CITY OF TAYLOR, TEXAS

PLANNING AND ZONING COMMISSION MEETING

July 13, 2021, 6:00 P.M.

Staff has completed its review of plans for the RCR Phase 2 Preliminary Plat that is to be located at 201 FM3349, Taylor, TX 76574. There are some corrections that need to be made prior to recordation of the plat. Comments from this review follow.

VICINITY MAP
(NOT TO SCALE)

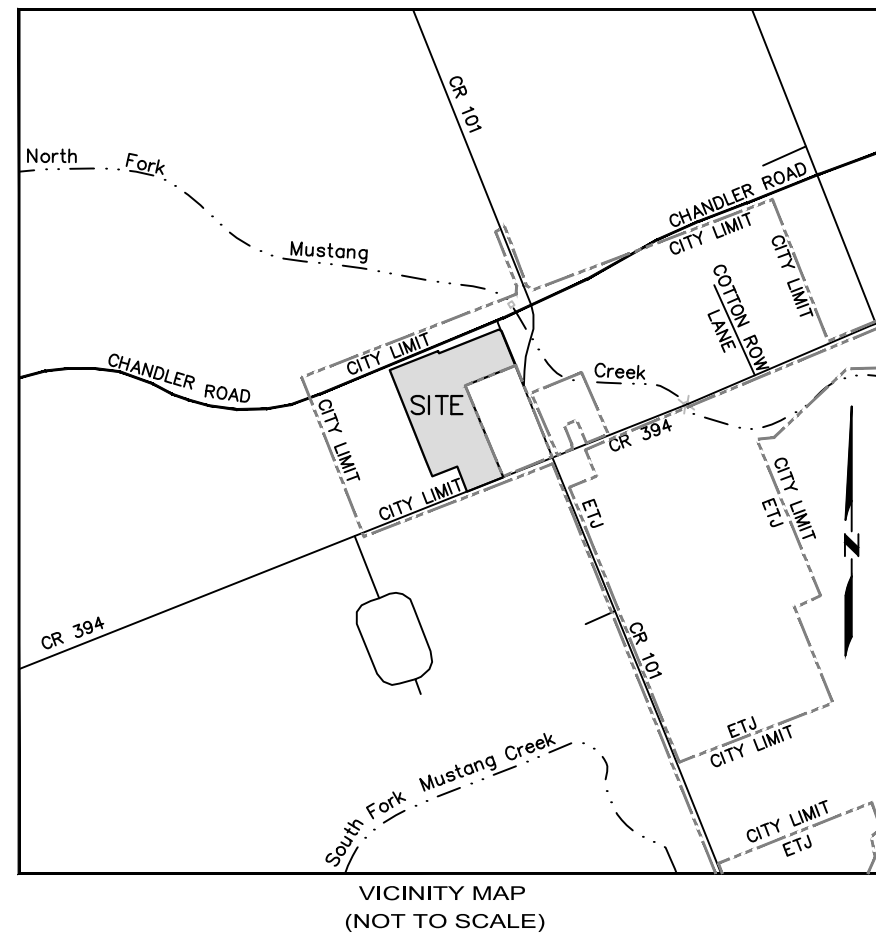
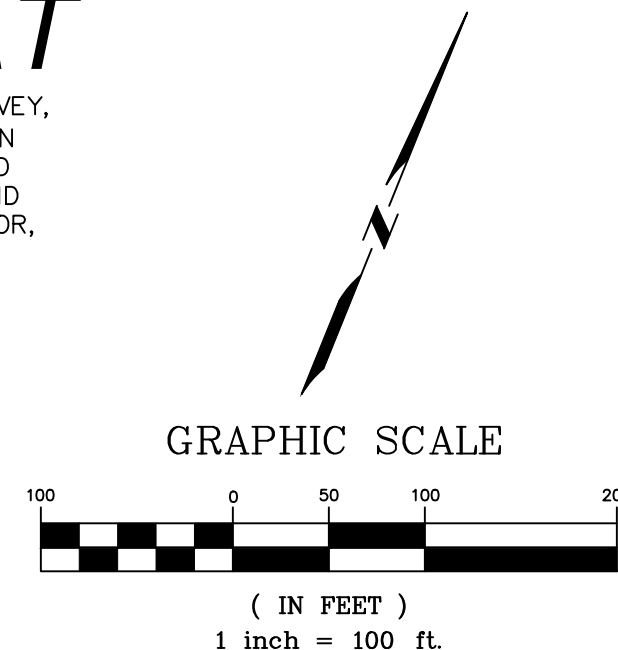
Provide the right-of-way dimensions. Stating that right-of-way width is variable is not adequate. It's not possible to tell if dedication is needed.

The correct symbology for a public utility easement (PUE) is a dashed line so that needs to be corrected. PUEs are not within the right-of-way. PUEs are on private property and it must be depicted correctly on the plat. Include in Legend.

Update the amount of right-of-way being dedicated on Sheet 1 (next to the Vicinity Map).

SINGLE-FAMILY LOT BUILDING SETBACKS (B.L.) & PUBLIC UTILITY EASEMENTS (P.U.E.)

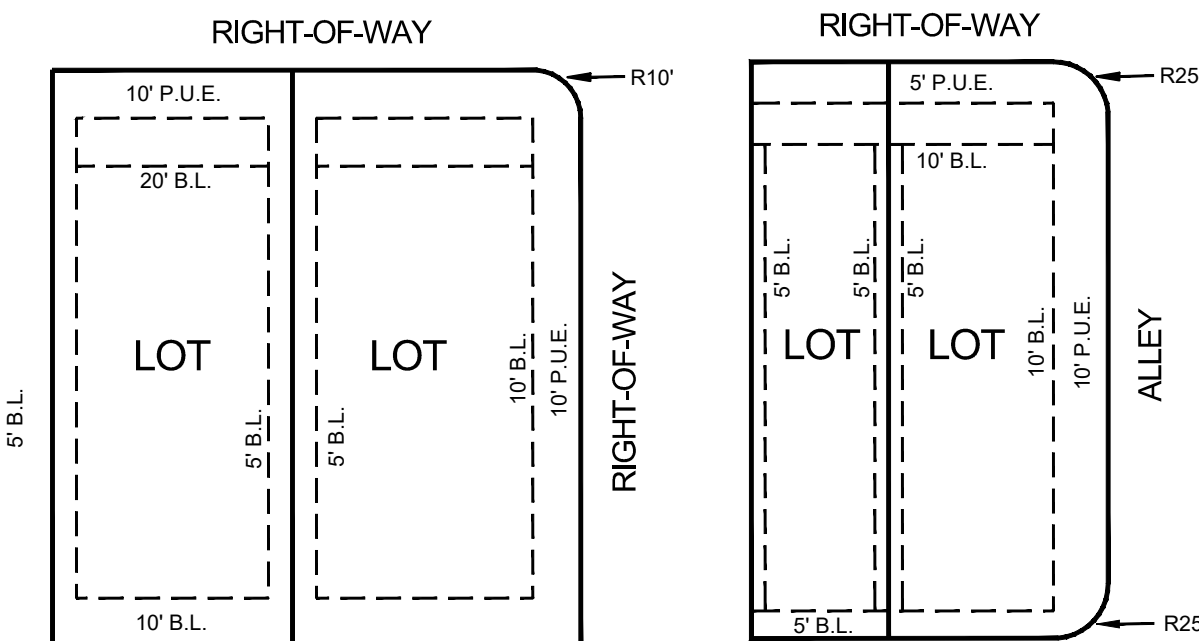
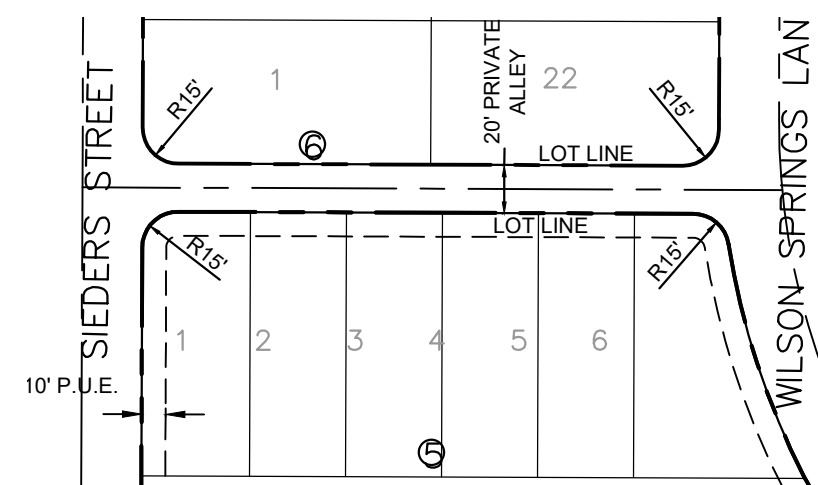
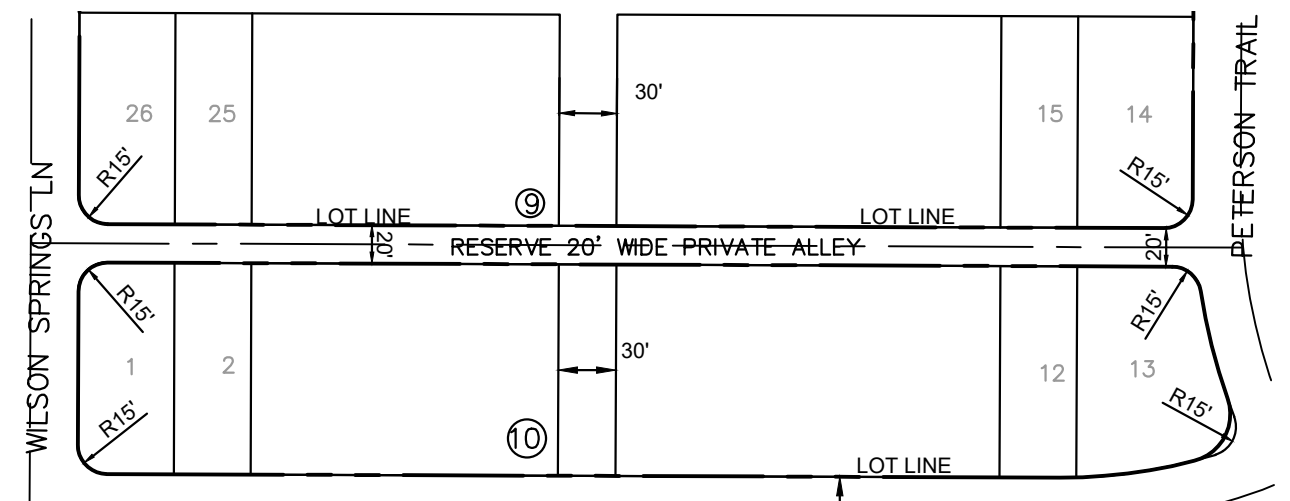
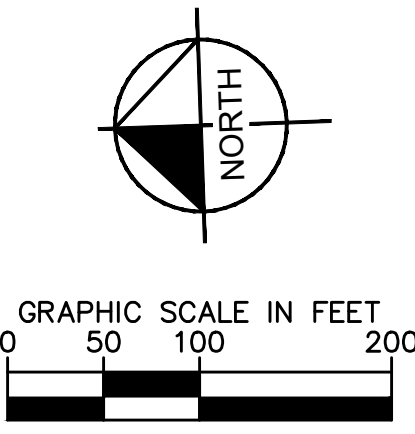
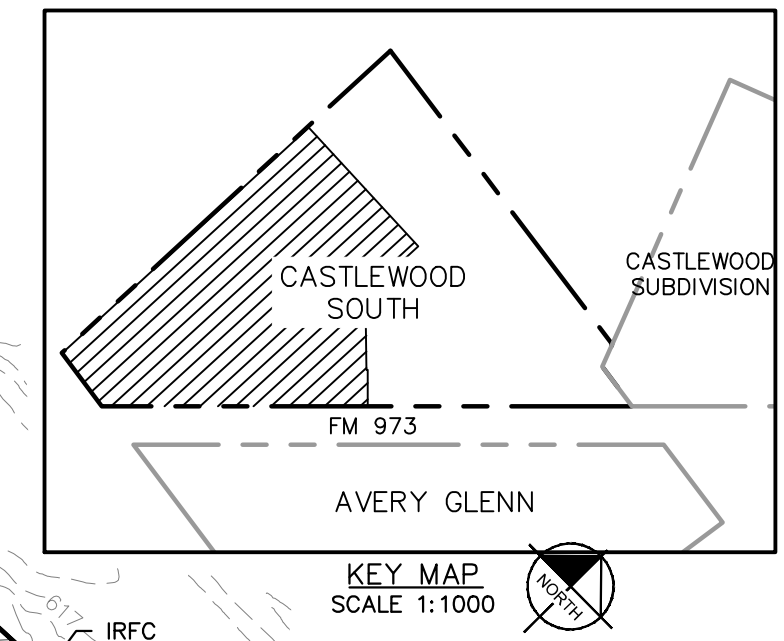
This was corrected but it's not possible to tell the front of the lot from the back of the lot. In G. Development Standards of the Planned Development the front setbacks for the alley loaded lots is five (5) feet and rear setback is 10 feet. See Planned Development.

The minimum lot size for alley loaded lots is 3,850 in G. Development Standards. The note on the left hand side of Sheet 1 notes the smallest townhome lot as .1010 acres. This is in the Planned Development Ordinance so a note could be placed in the General Notes that states the minimum lot sizes are in accordance with the Planned Development Ordinance.

On Sheet 1, the top right detail is labeled as Townhome Building Setbacks.....There are not any townhomes in this project. Make the correction.
